An Bord Pleanála

DART UNDERGROUND

REPORT ON TRAFFIC AND TRANSPORTATION

This report has been produced by Steve Wallace BSc, CEng, MICE, MCIHT, CMILT, MIEI who has been appointed by An Bord Pleanála to assist the Inspector in the consideration of traffic matters relating to the Railway Order application for the DART Underground strategic infrastructure development.

Figure 4.1 Pedestrian Routes between proposed Docklands Station entrance and Church Street - St Mary's Road junction in centre of East Wall community

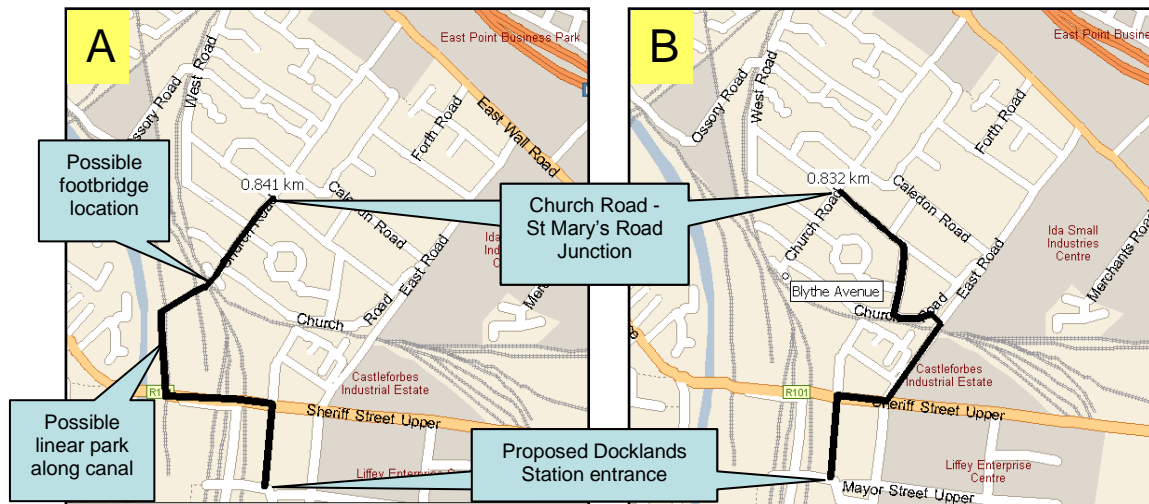
It is proposed to locate the Docklands Station immediately to the south of Spencer Dock LUAS stop with dual access points at Mayor Street and also through the LMS building from North Wall Quay. Such a location means there is good walk-in access from all the Docklands development area to the north of the river and also a significant part to the south, which could be gained via Samuel Beckett Bridge. A substantial part (around 75%) of the East Wall community also lies within a 1 kilometre walk of the station entrance, albeit the routing is not on the natural “desire line”. This is a consequence of the existing available crossings of railway lands in the area. Whilst East Wall observers to the Railway Order Application made requests that a footbridge at Blythe Avenue be provided to allow greater accessibility to Docklands Station, it is considered that such provision is not an essential “mitigation” to overcome a particular impact. The submitted design does not preclude the provision of a pedestrian facility as a separate project in the future, possibly as part of the initiative to create a linear park along the edge of the Royal Canal. Such a concept was introduced in the East Wall Area Action Plan in 2004. Whilst the provision of such a facility would lead to better accessibility between East Wall and the IFSC area generally, it would not shorten the distance to the proposed underground station at Docklands for East Wall residents. This is demonstrated in Figure 4.1 below.

A : via possible future linear park and footbridge at Blyth Avenue - approx 0.8 km

B : via existing East Road bridge - approx 0.8 km

I therefore conclude that a footbridge should not be considered as a means of mitigating or improving access between the proposed Docklands Station and East Wall.
